Release Notes for DrayTek Vigor2860 series (UK/Ireland)

Firmware Version	3.8.9.6_BT (Formal Release)
Release Type	Regular – Upgrade recommended when convenient
Build Date	16 th October 2019
Release Date	12 th November 2019
Revision	85472
Applicable Models	Vigor2860, Vigor2860n, Vigor2860Vn, Vigor 2860n+, Vigor 2860Vn+ Vigor 2860ac, Vigor 2860Vac, Vigor 2860L, Vigor 2860Ln
Locale	UK & Ireland Only

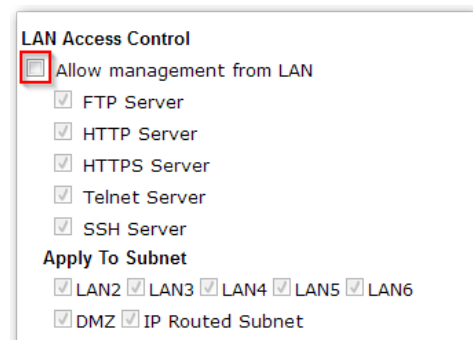
2. Upgrading a unit which has "Allow Management from LAN" DISABLED as shown in the screenshot, will result in the router's management interface(s) not responding on LAN1 after the upgrade. To avoid this, we recommend enabling "Allow management from LAN" before upgrading the router's firmware to 3.8.5. After upgrade the setting can be set as required and can also be applied to LAN1

In the event that access to management is unavailable on LAN1, either change the LAN Access Control configuration by managing from the Internet, or downgrade to the previous firmware version with the DrayTek Firmware Upgrade utility to regain access via LAN1.
